# 13 SUB2014-00157

## EMOGENE/SPRINGDALE SUBDIVISION, LOT B REPLAT

APPLICATION NUMBER 13 DATE January 15, 2015

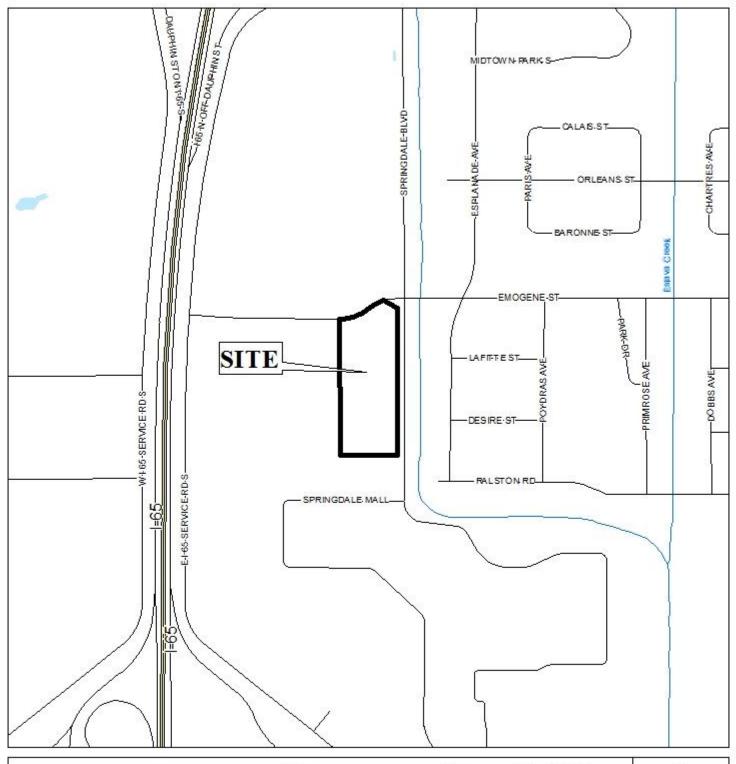
The 25-foot minimum building setback line, required in Section V.D.9., is not shown for the subdivision, but would be required on the final plat, if approved.

Various drainage and utility easements are depicted on the preliminary plat. A note should be added to the final plat, if approved, stating that no structures may be built within any drainage or utility easements.

- 1) an application for Administrative Planned Unit Development review will be required prior to the development of Lot B-1, to address the cross-access easement with Lot B-2;

- 2) placement of a note on the final plat stating that Lot B-1 is limited to two curb-cuts to Springdale Boulevard, and that Lot B-2 be limited to one curb-cut to Emogene Street and one curb-cut to Springdale Boulevard, with the size, design and location of all curb-cuts to be approved by Traffic Engineering and conform to AASHTO standards;

- 3) placement of a note on the final plat stating that no structures may be built within any drainage or utility easements;
- 4) depiction of the 25-foot minimum building setback line from all street frontages as required by Section V.D.9. of the Subdivision Regulations;

- 5) the labeling of each lot with its size in square feet, or placement of a table on the plat with the same information;
- 6) compliance with Engineering comments (*The following comments should be addressed prior to submitting the FINAL PLAT for acceptance and signature by the City Engineer:*
